Addendum No.: 3

Date Of Addendum: July 05, 2017

State Veterans' Cemetery Phase II Expansion
317 Bow Lane, Middletown, CT 06457
BI - C - 293 / FAI CT-16-03

1 WATER METER PIT DETAIL

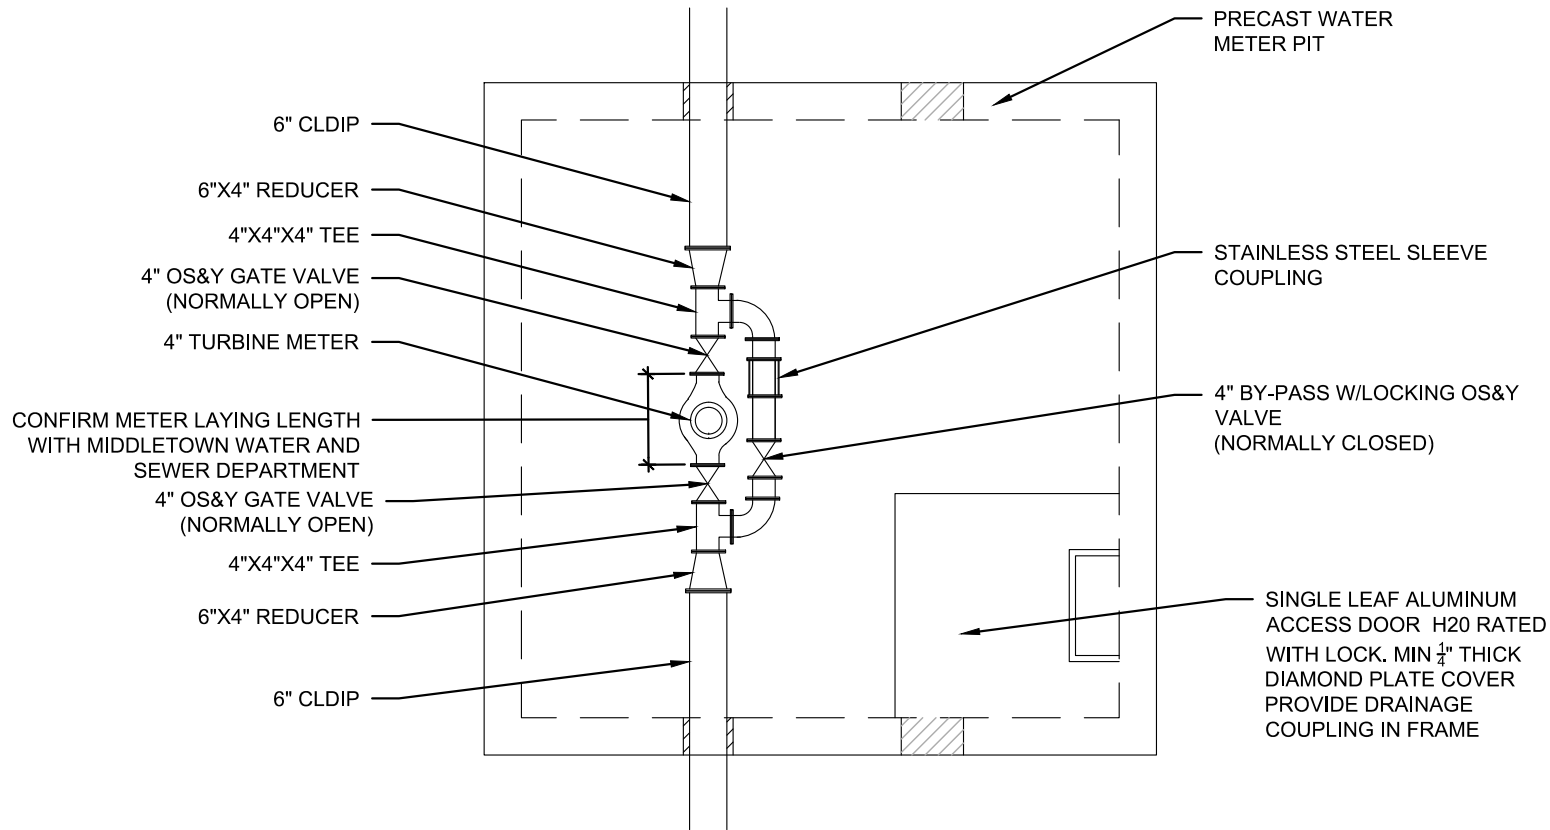
ADD drawing sketches SKC.01 and SKC.02 (attached) to clarify details of the water meter pit identified on Sheet C.04B of the Contract Documents.
